Application for Planning Permission for Proposed Temporary Warehouse for Storage of Construction Materials (Timber and Metal) and Associated Filling of Land for a Period of 3 Years at Lots 123 RP, 124 (Part), 125 (Part), 126 (Part) and 127 (Part) in D.D. 113 and Adjoining Government Land, Ma On Kong, Kam Tin South, Yuen Long, N.T.
(Application No. A/YL-KTS/1147)

Table 1: Responses to Departmental Comments (Application No. A/NE-KTS/1147) (21 September, 2026)

Responses to Comments from Government Departments on Drainage Submission (June 2026) of Planning Application No. A/YL-KTS/1147

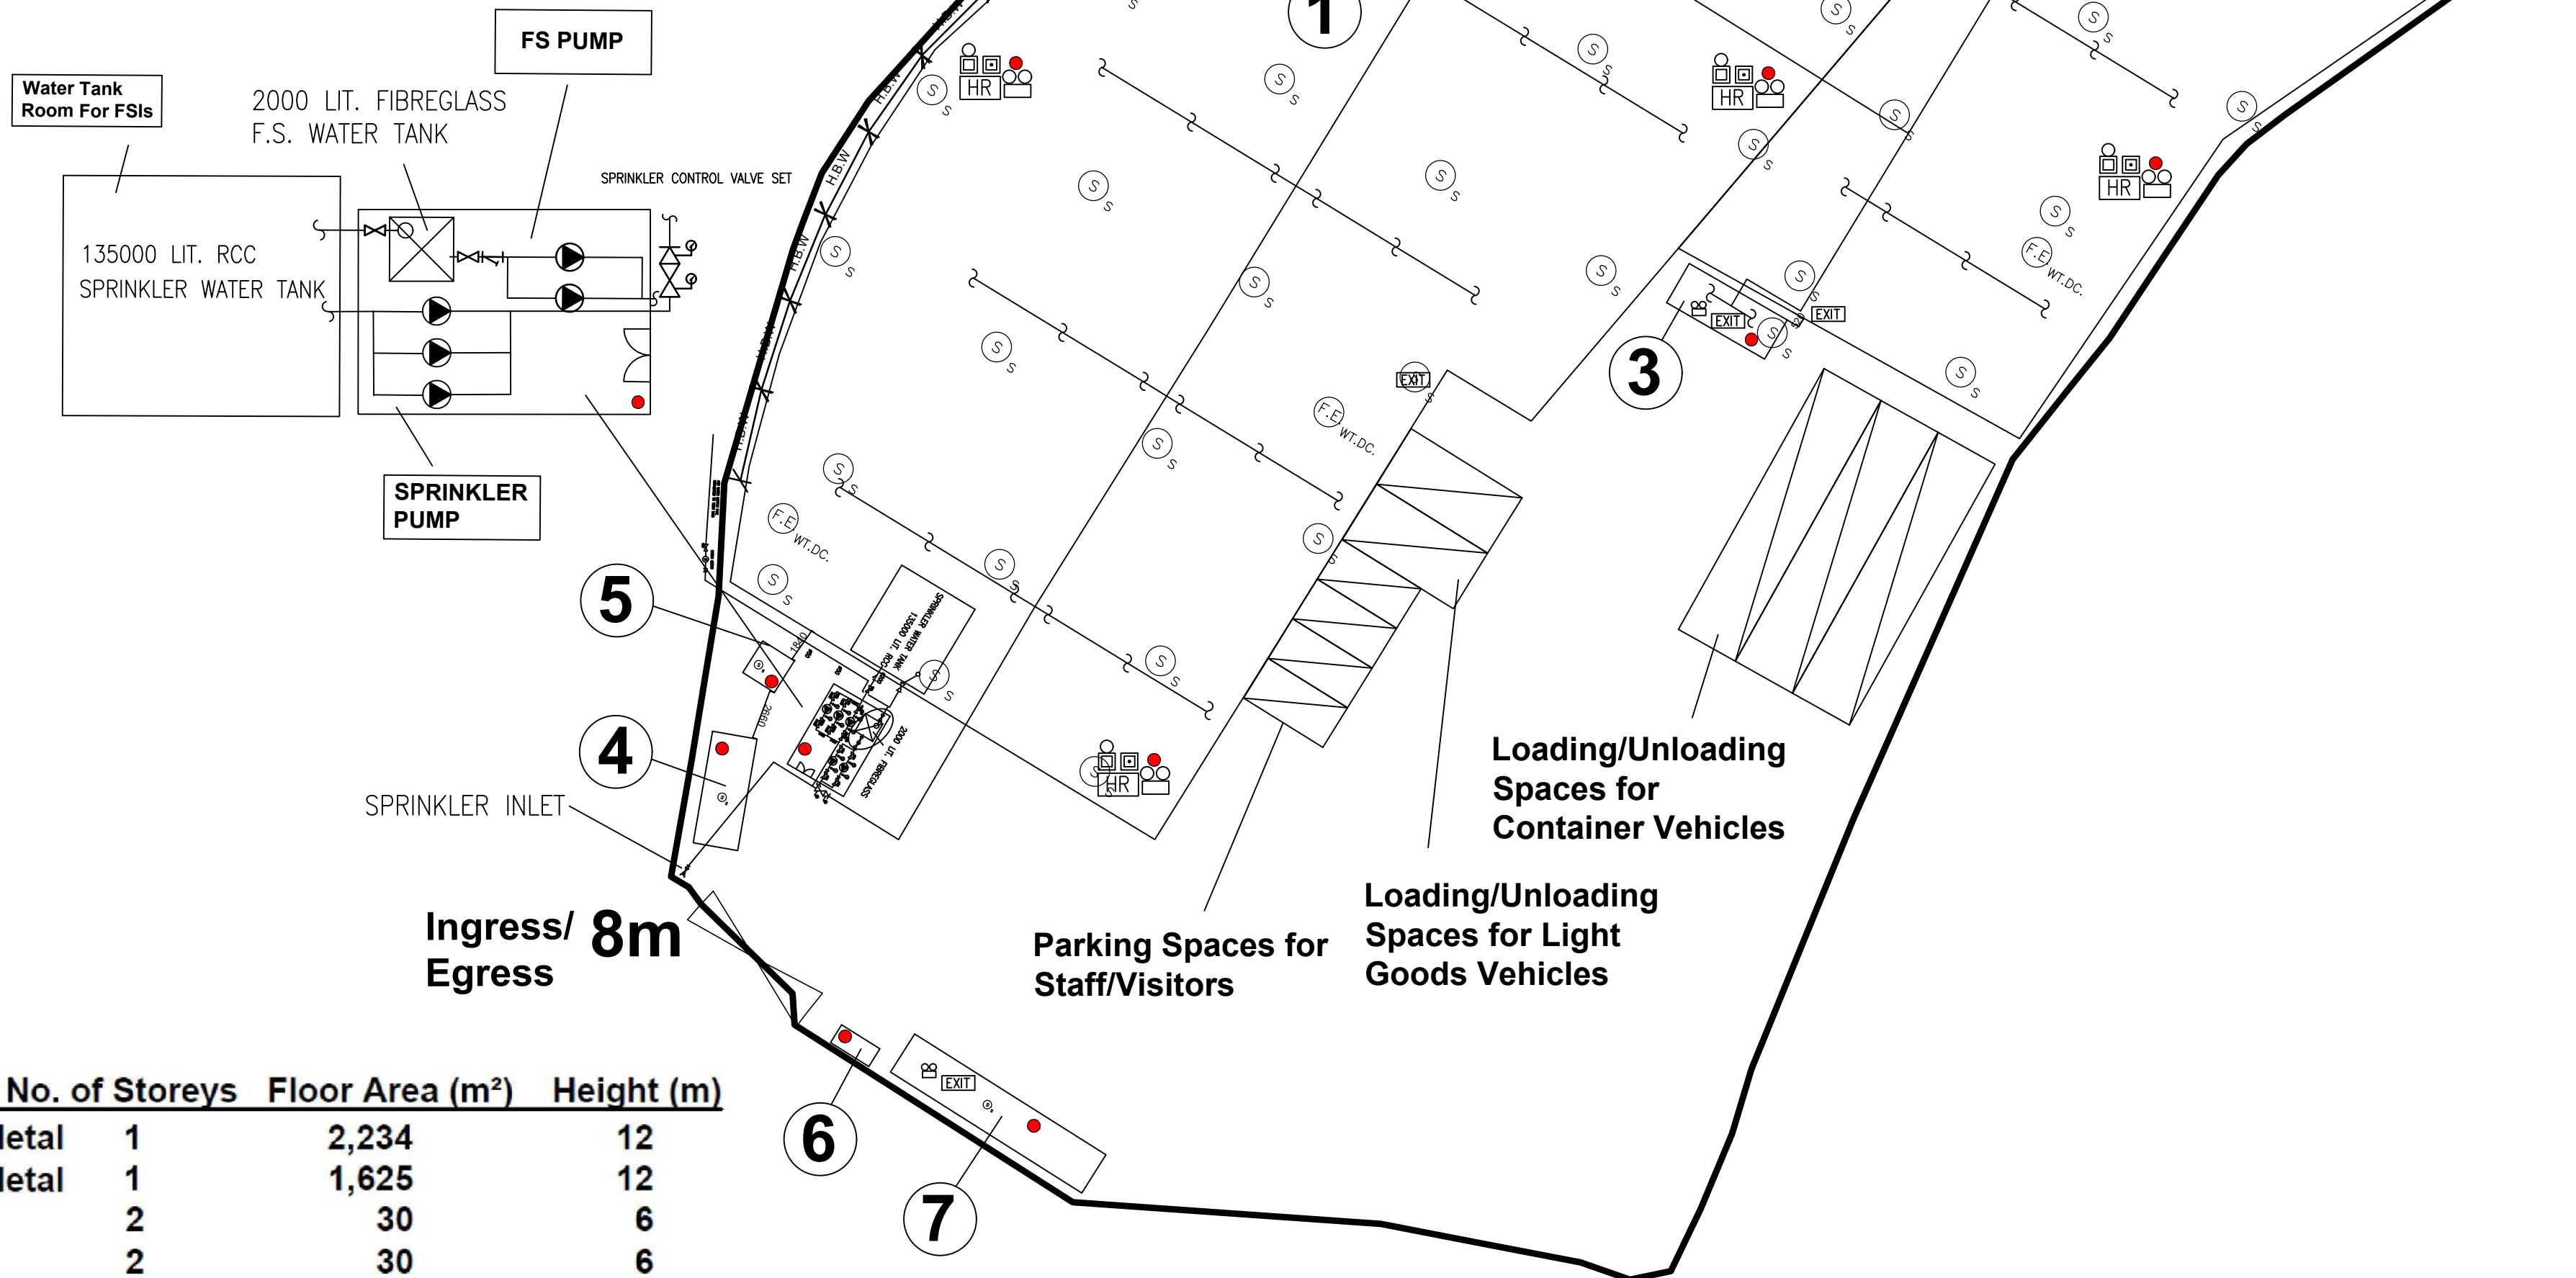
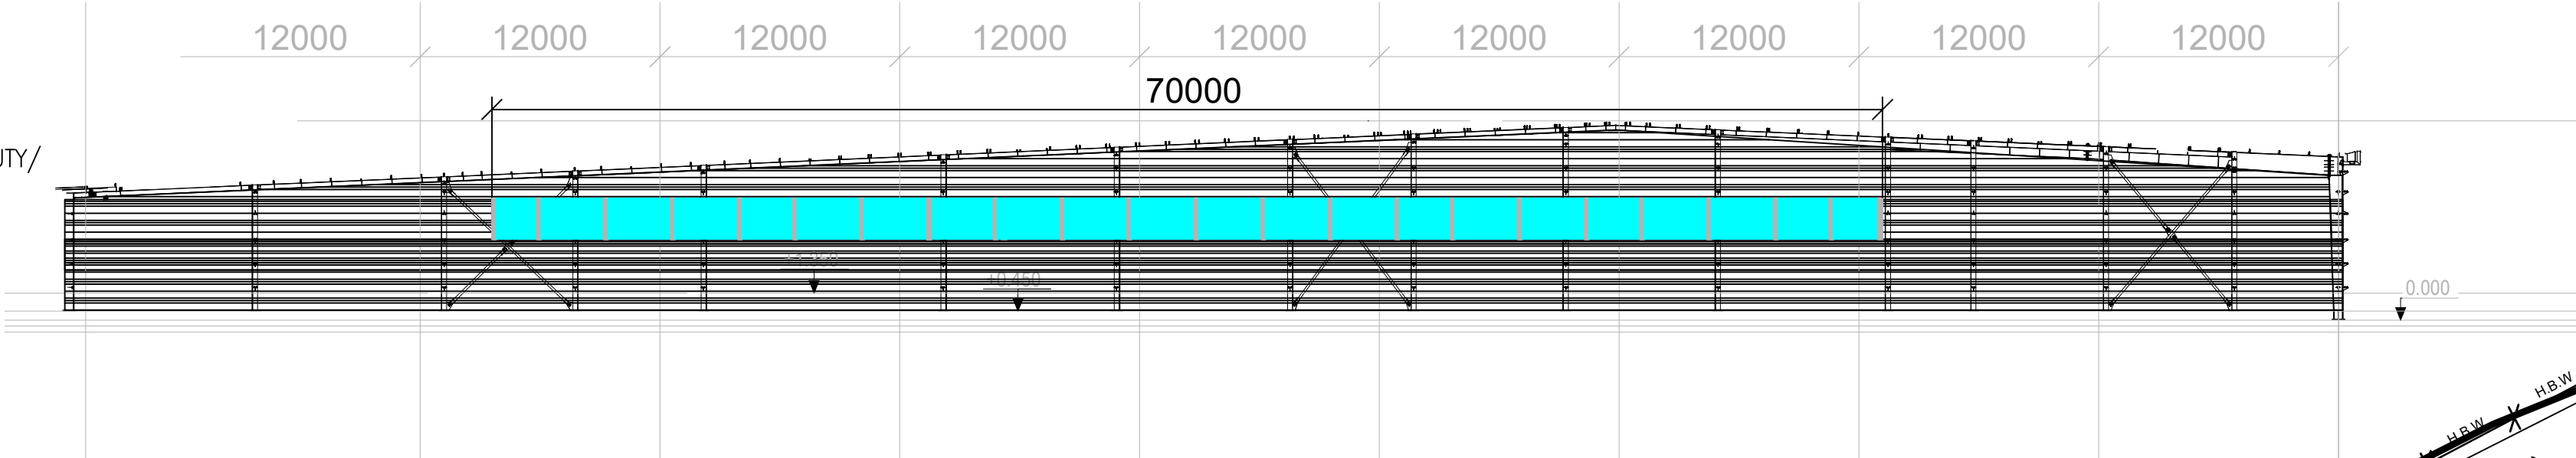
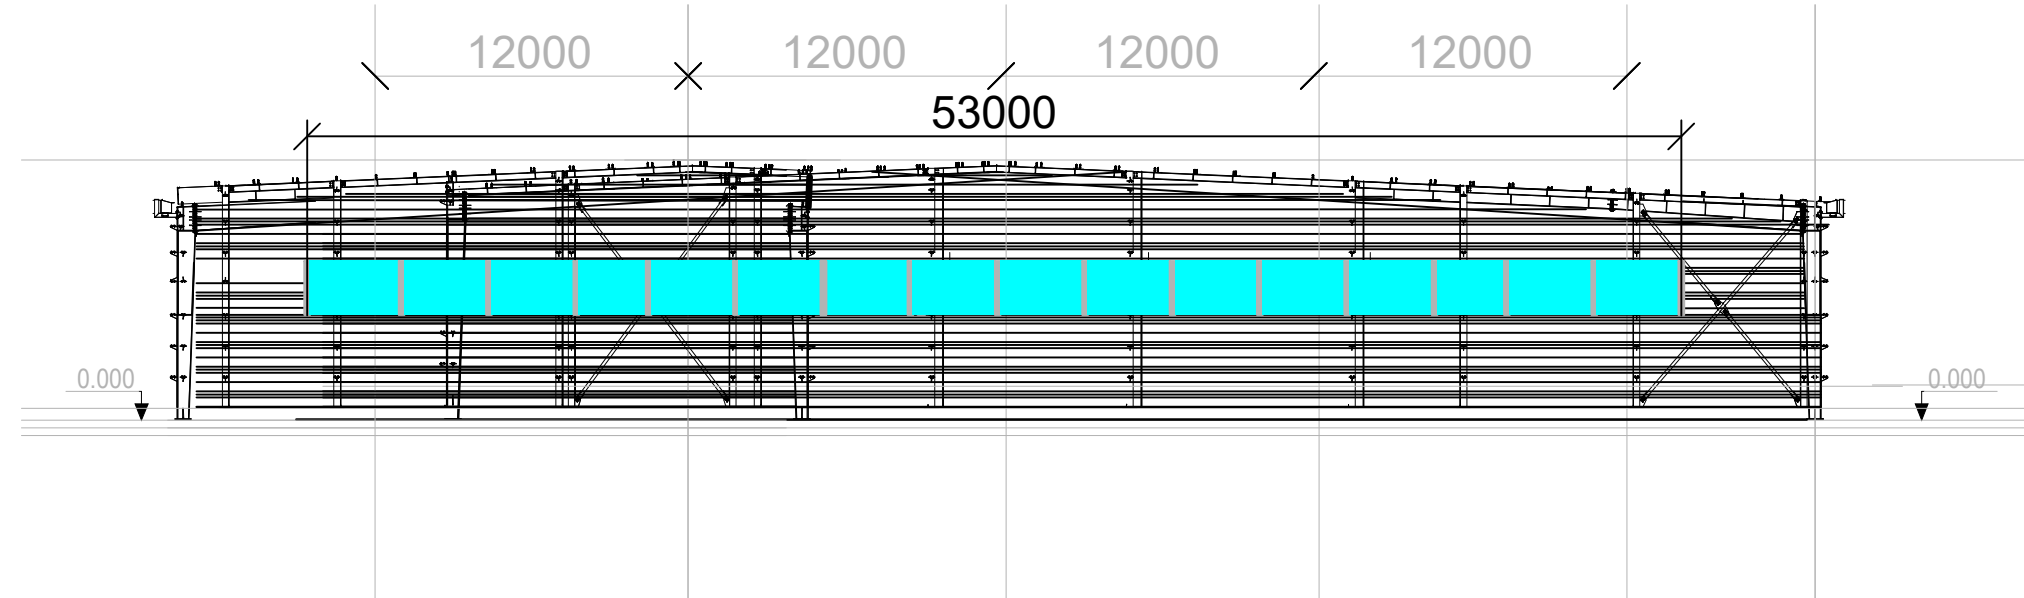
(vi)	Separation distance between each structure shall be clearly indicated on the plan;	Noted. Separation distance between each structure has been indicated on the updated FSIs proposal.
(vii)	In relation to item (vi) above, structures on the same site are regarded as adjoining structures if they are less than 1.8 m apart. In this regard, sprinkler system, wheeled type dry chemical fire extinguisher, stand-alone fire detector, emergency lighting and directional & exit signs shall be provided if the total floor area exceeds 230 m ² ;	Noted.
(viii)	Modified hose reel system is considered as a self-upgrade and is not a mandatory requirement of this Department;	Noted.
(ix)	For shed(s) open on 2 sides or more, i.e. Structure 6, fire extinguishers shall be provided; and	Noted. Fire extinguisher will be provided for Structure 6.

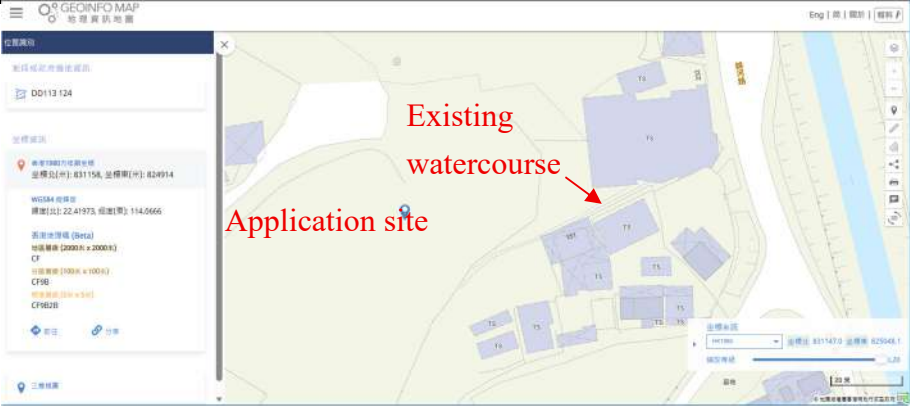
(ii)	The ground to the southwest of the application site is significantly higher. Since the overland flow from the adjacent lands shall be probably intercepted, external catchment shall be considered in the calculation. Please make reference to the latest Technical Note No. 1 issued by DSD for more details in preparing the drainage proposal. Please upgrade all drainage facilities size accordingly.		The open area in front of the application site entrance has already been included in the stormwater catchment area of the application site. The ground to the southwest of the application site is significantly higher. However, there is an existing access road running between the higher ground to the southwest and the application site. The levels of the existing access road are relatively lower than the ground levels of the both sides as shown in the following photo:

COMMENTS	RESPONSES
	 Surface runoff from the southwest of the application site would hence flow along the access road to the downstream into an existing watercourse running outside the southeast boundary of the application site and the existing watercourse runs directly towards Kam Ho Road direction without crossing the application site. Please refer to the illustration in the following:

COMMENTS	RESPONSES
	 The screenshot shows a GIS application window titled 'GEOINFO MAP'. On the left, a sidebar lists various map layers including 'DD113 124', 'W0304 01 0001', and 'W0304 01 0002'. The main map area displays a topographic map with building footprints. A red arrow points to a specific location labeled 'Application site'. Another red arrow points to a nearby feature labeled 'Existing watercourse'. The map includes a scale bar and a north arrow.  The photograph shows a narrow, shallow watercourse flowing through a grassy area. A red arrow points to the watercourse, which is bordered by a concrete wall on the left and dense vegetation on the right. The text 'Existing watercourse running outside the southeast boundary of the application site' is overlaid in red.

COMMENTS	RESPONSES
	  Therefore, all the overland flow from the ground to the southwest of the application site would be intercepted by the existing access road and diverted to the downstream along the existing access road instead
